CITY OF NEW YORK  
**MANHATTAN COMMUNITY BOARD FOUR**

**Re: Newsstand Application on West 30<sup>th</sup> Street, West of Tenth Avenue, PHA #0852V**  
**Application #: 10257-2019-ANWS**

**TO:** Related Companies  
**FROM:** Philip Habib & Associates  
**DATE:** September 16<sup>th</sup>, 2019  
**RE:** 10 HY Newsstand Application Assessment (PHA #0852V)

**Figure 2 – Compliant Newsstand Rules Schematic**

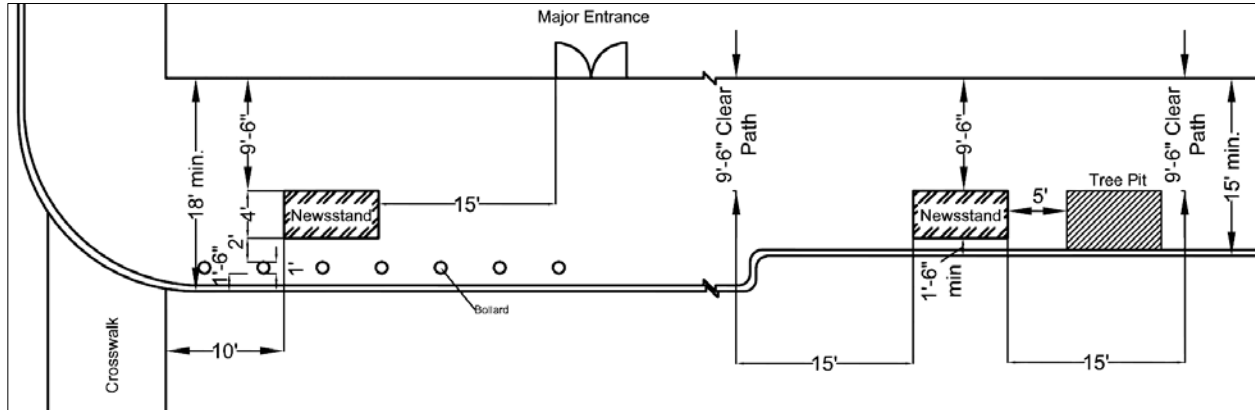
\*Assumes ideal two feet from bollard face to clear bollard footing from newsstand foundation.

**TITLE:**  
NEWSSTAND  
LOCATION CLEAR  
PATH AND  
SURROUNDINGS

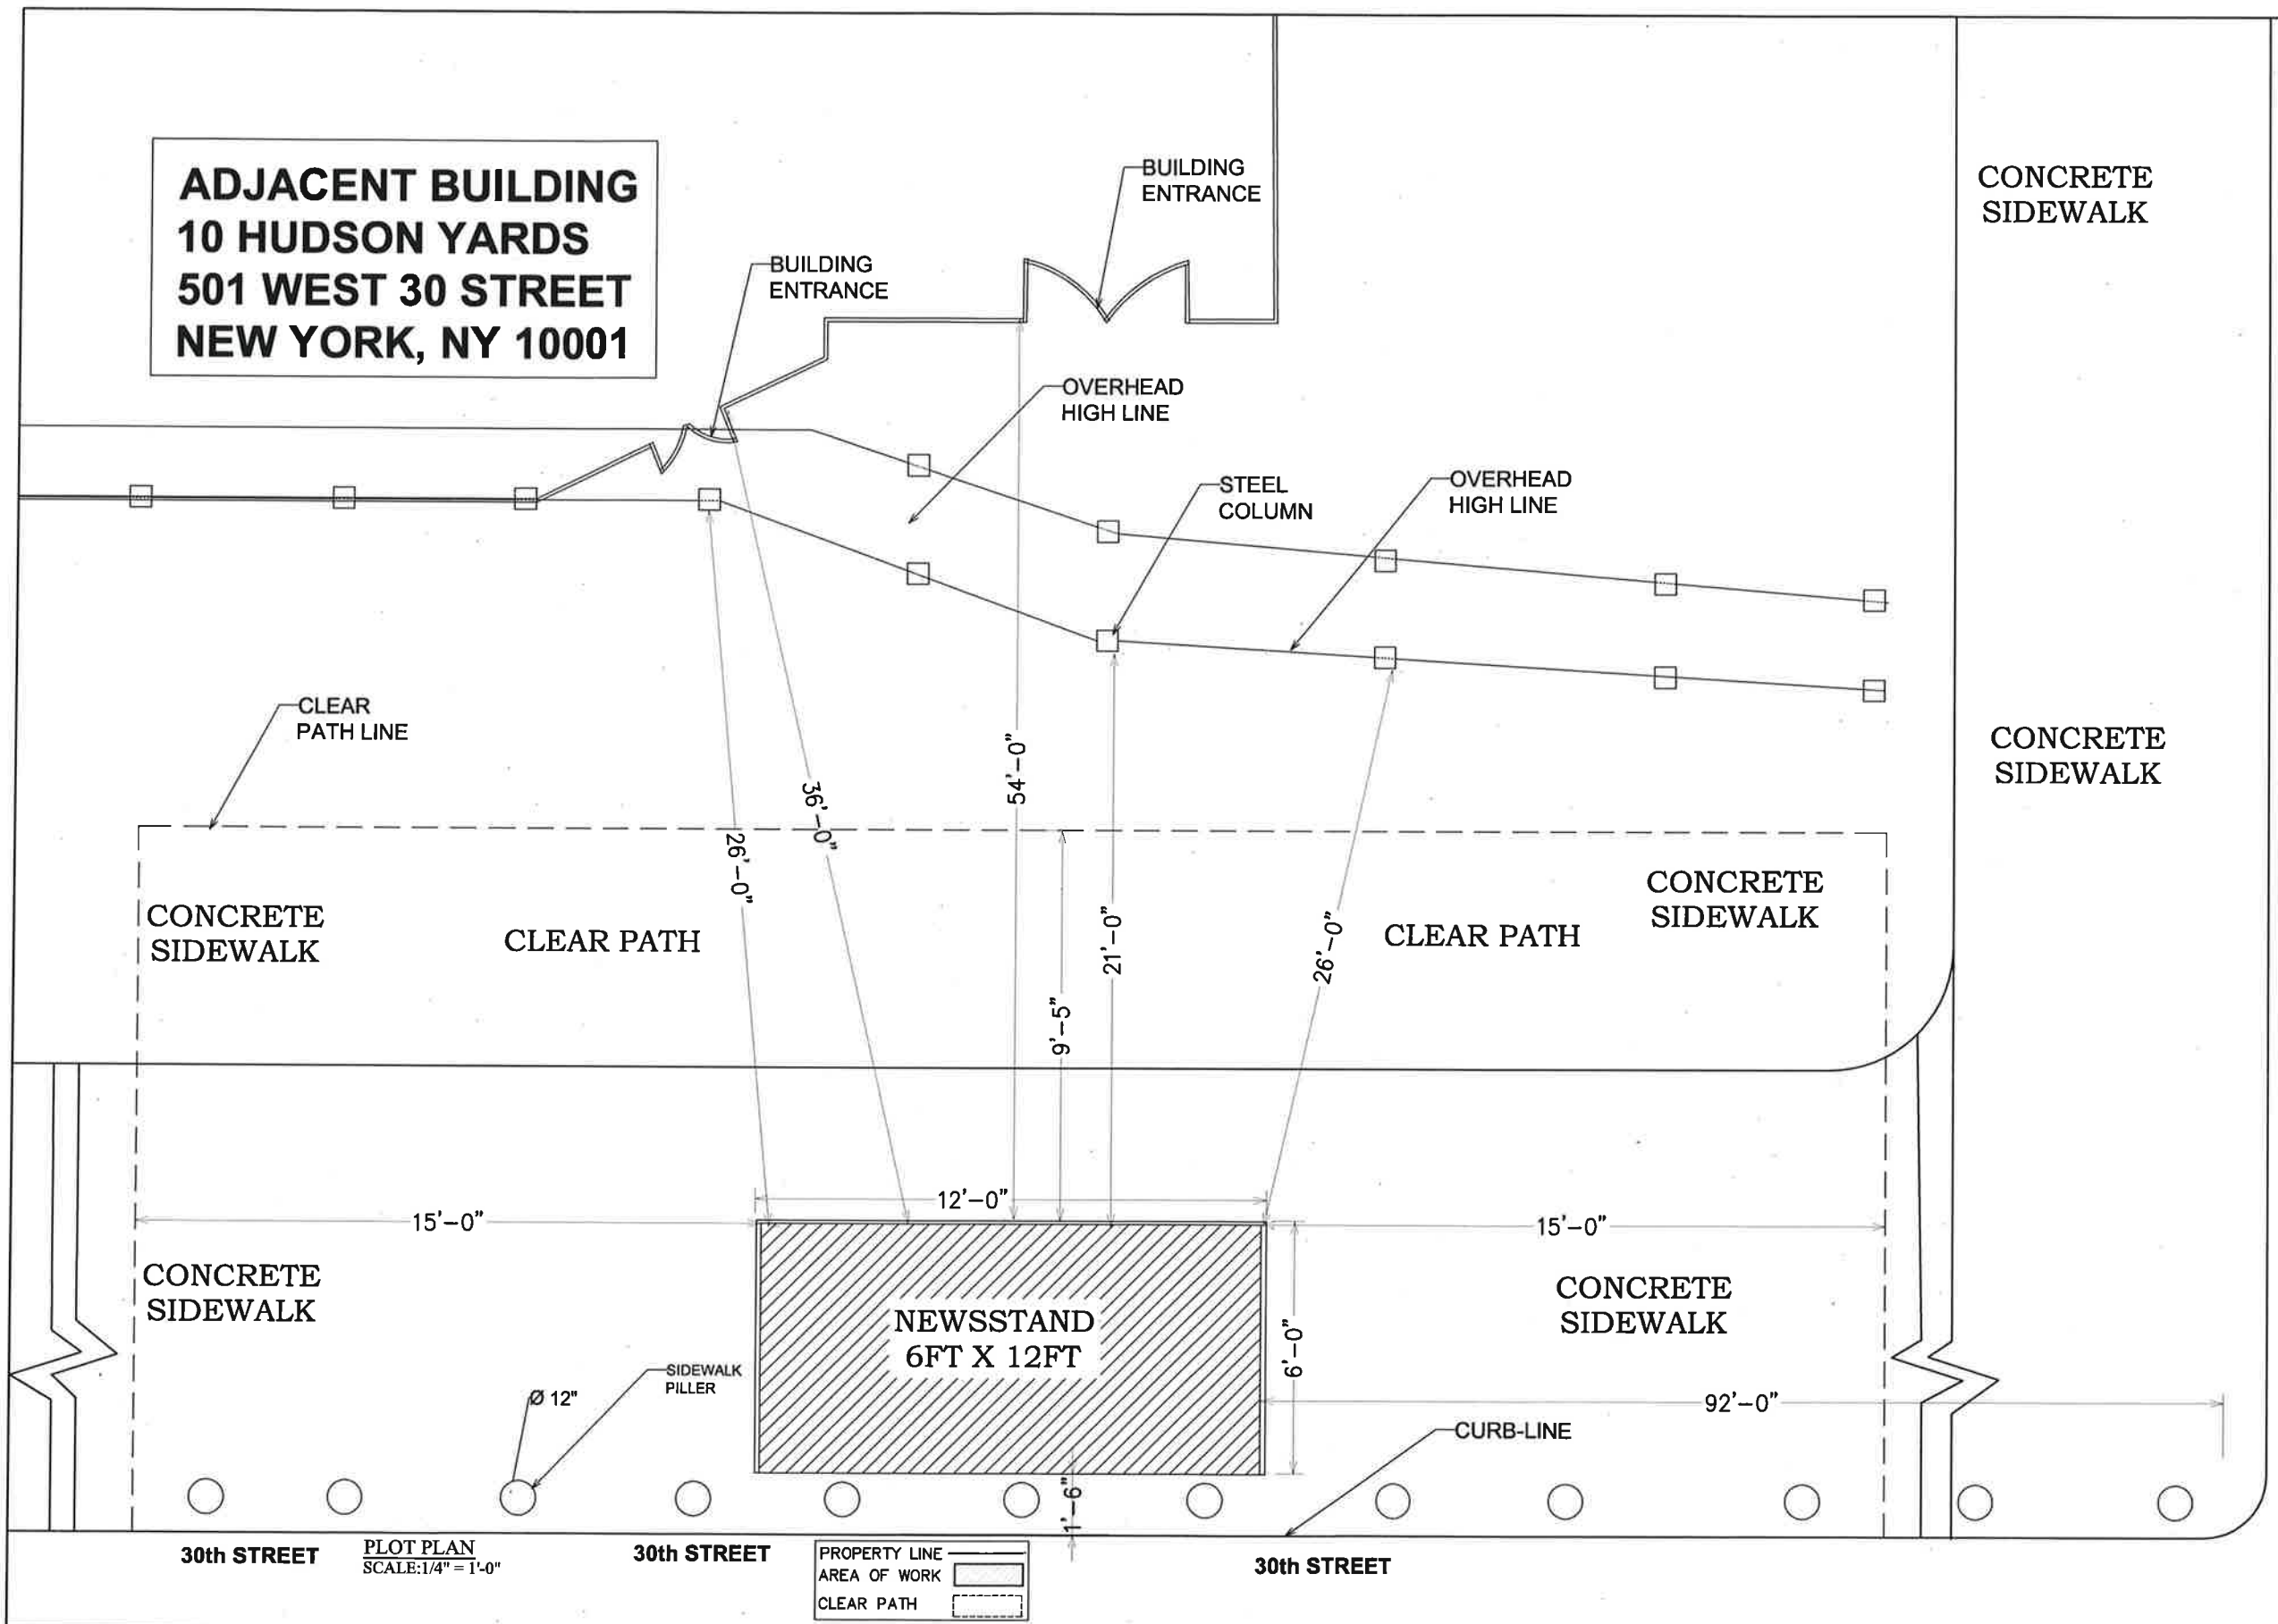
Rule	Compliant?	Provided
At least 1.5' from curb line.	Yes	Application incorrectly indicates that newsstand would be 1.5' from the curb. Fails to consider the bollard is located 1.5' from the curb. The stand would need to be at least 2.5' from the curb (adjacent to the bollard). This does not consider that the newsstand foundation could interact with the bollard footing, which extends 3'-3" from the curb line. See Figure 3.
At least 9.5' clear path in front of stand and 15' on either side \.	No	If the 6'x12' newsstand were placed in front of installed bollard, there would only be 6.5' of clear path on the public sidewalk (See Figure 3). The smallest potential newsstand of 4' would only provide 8.5' clear path.
15' (parallel to the curb) from a major entrance/egress.	No	The newsstand would be located directly in front of the revolving doors and not offset 15' east or west from the access/egress point. This would restrict emergency access to the office entrance.

PHA was able to determine that the application for a newsstand on the West 30<sup>th</sup> Street frontage of 10 Hudson Yard inaccurately and incorrectly illustrates the proposed newsstand relative to the existing surrounding infrastructure, including existing bollards. The newsstand would not provide the required minimum clearance of 9.5' and would not be in adherence to the 15' major entrance rule. The proposed newsstand would not be compliant with all the regulations of *The Rules of the City of New York (RCNY)*. The newsstand would also be located directly above a Con-Ed conduit and sewer connection. As such, the newsstand application, filed on the West 30<sup>th</sup> Street frontage of 501 West 30<sup>th</sup> Street (aka 10 Hudson Yards), should be rejected.

TITLE:  
NEWSSTAND LOCATION  
MAP AND CLEAR PATH.

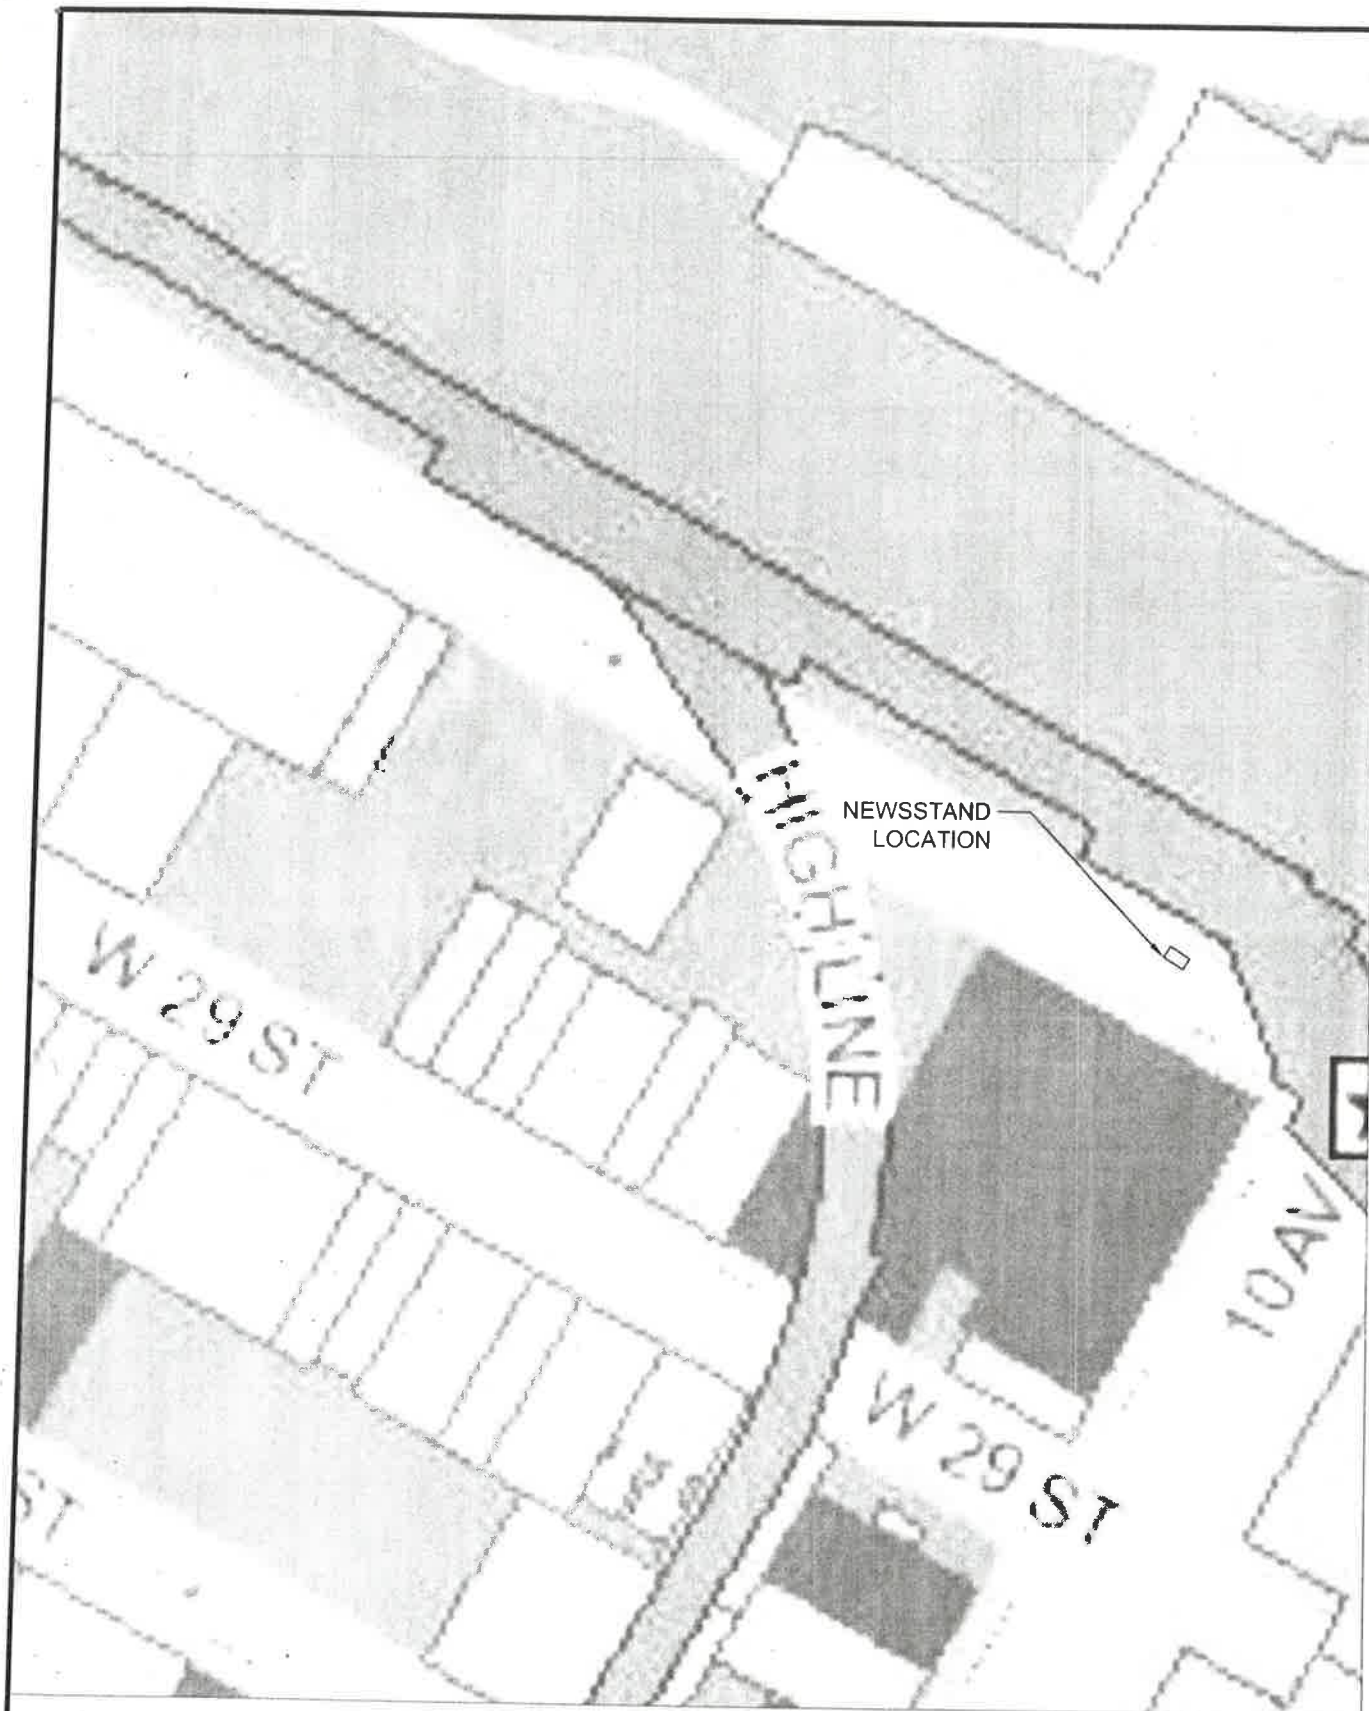
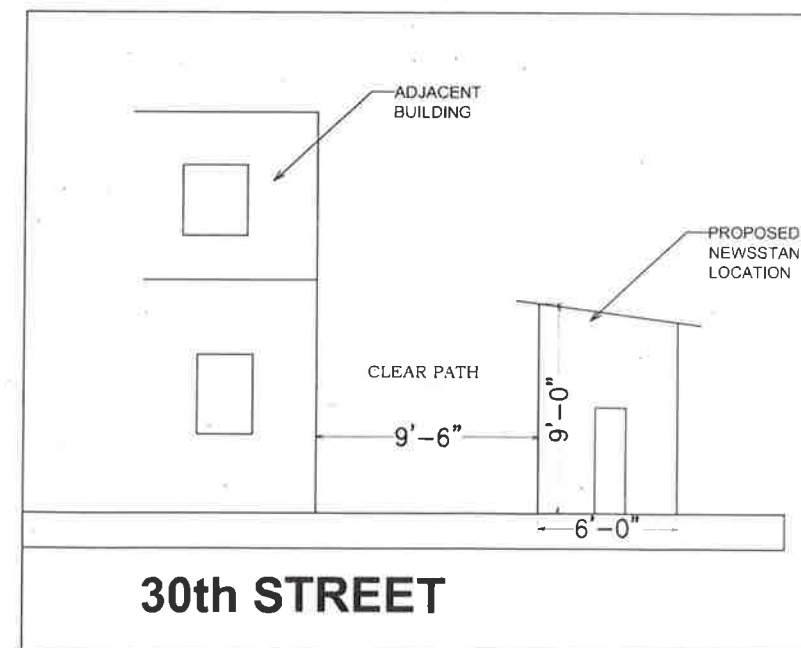
The current application for a 12'x 6' newsstand, located 90' east of Tenth Avenue on the north side of West 30<sup>th</sup> Street is problematic. It does not account for the presence of security bollards along the curb, resulting in an inadequate 6'5" pedestrian path between the newsstand and the property line.
